BMA Caval Ridge Mine Project

Change Request Accommodation Location and Capacity

September 2010

Figure 1: Village Location

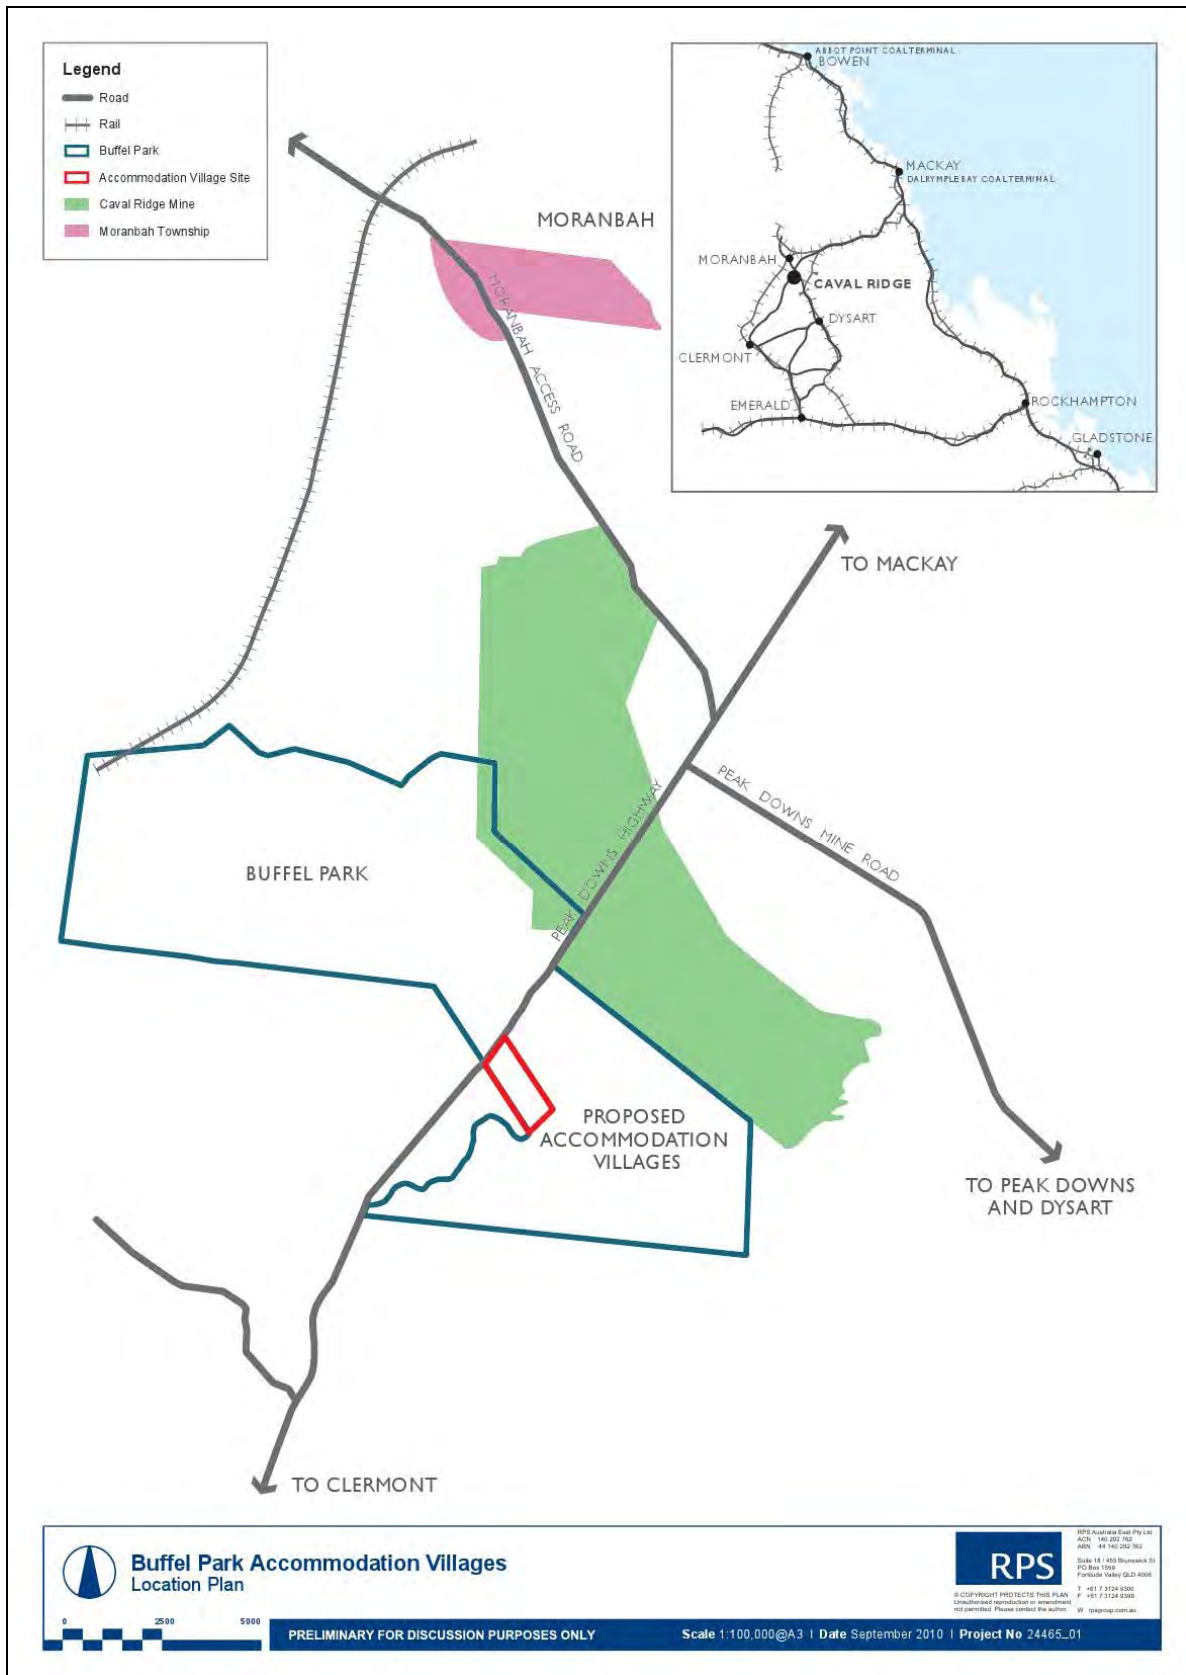
The specific location of the proposed Buffel Village is on the south-eastern side of Peak Downs Highway to the south of the proposed CRM. The location and extent of the Buffel Village footprint is shown as Figure 1.

Figure 2: Village Layout

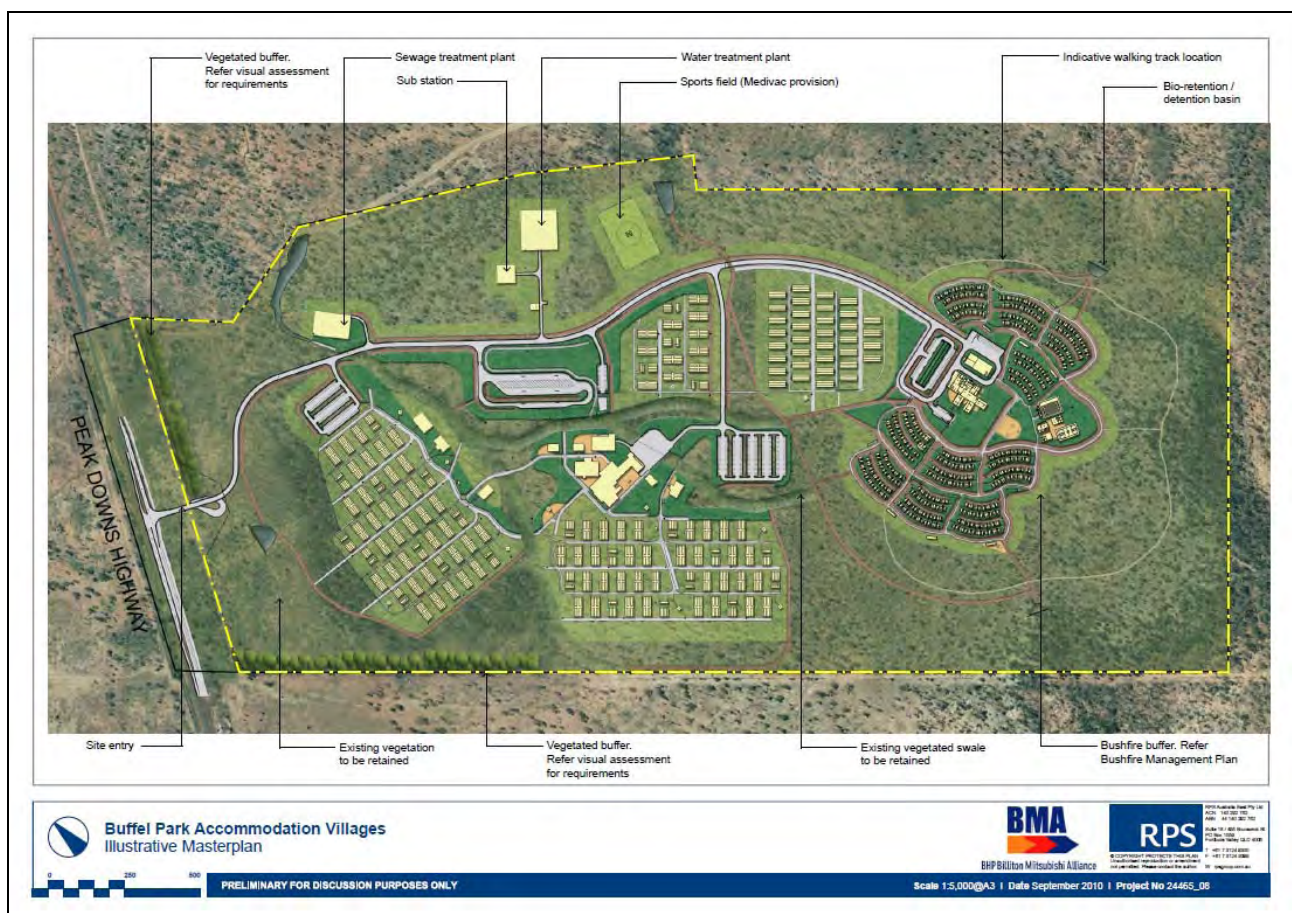
The Accommodation Villages Masterplan Structure (RPS Drawing 24465_09 dated September 2010), illustrated as Figure 2 and contained in Appendix C to the DA, illustrates the overall pattern of development, showing:

- The access and service road extending from the Peak Downs Highway into the site;
- The common infrastructure and services area located to the north of the service road;
- The Construction Village, including its core facilities as the western portion of the development footprint;
- The Operations Village, including its core facilities as the eastern portion of the development footprint; and
- Bushland and open space around the periphery of the site providing a landscape buffer, including areas where revegetation is proposed to minimise the visual impacts of the development and provide opportunities for active and passive recreation.
